INLAND TRANSPORT COMMITTEE

Working Party on the Transport of Dangerous Goods (Seventy-third session, Geneva, 4-8 November 2002) agenda item 3(b)

Transmitted by the Government of Italy

Italian	proposal (doc. TRANS/WP.15/2002/18)	Comments, decisions and proposals by other Countries
	PART 9 REQUIREMENTS CONCERNING THE CONSTRUCTION AND APPROVAL OF VEHICLE. CHAPTER 9.1 SCOPE, DEFINITIONS AND REQUIREMENTS FOR THE APPROVAL OF VEHICLES

9.2.1 EX/II, EX/III, FL, OX and AT vehicles shall comply with the requirements of this Chapter, according to the table below.

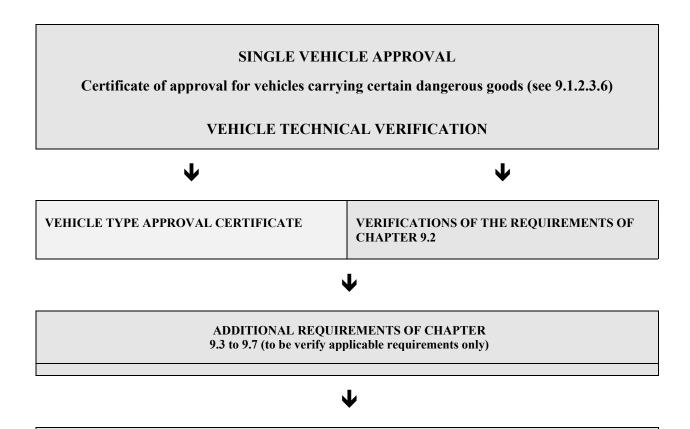
- the requirements of 9.2.3.1 (Brakes in accordance with ECE Regulation No. 13 or Directive 71/320/EEC) are applicable to all vehicles first registered (or which entered into service if the registration if not mandatory) after 30 -06-. June 1997;
- the requirements of 9.2.5 (Speed limitation device in accordance with ECE Regulation No. 89 or Directive 92/6/EEC) are applicable to all motor vehicles with a maximum mass exceeding 12 tonnes first registered [(or which entered into service if the registration if not mandatory)] after 31 12. December 1987.

Italian proposal (doc. TRANS/WP.15/2002/18)	Comments, decisions and proposals by other Countries
Table of the TECHNICAL SPECIFICATIONS: UNCHANGED	
Add the word "first" and the sentence "(or which \entered into service if the registration if not mandatory)" respectively before and after the word "registered" in point 9.2.5, comments column of the table "Technical specifications".	
Paragraphs 9.2.2 to 9.2.6 UNCHANGED	
Chapters 9.3 to 9.7 UNCHANGED
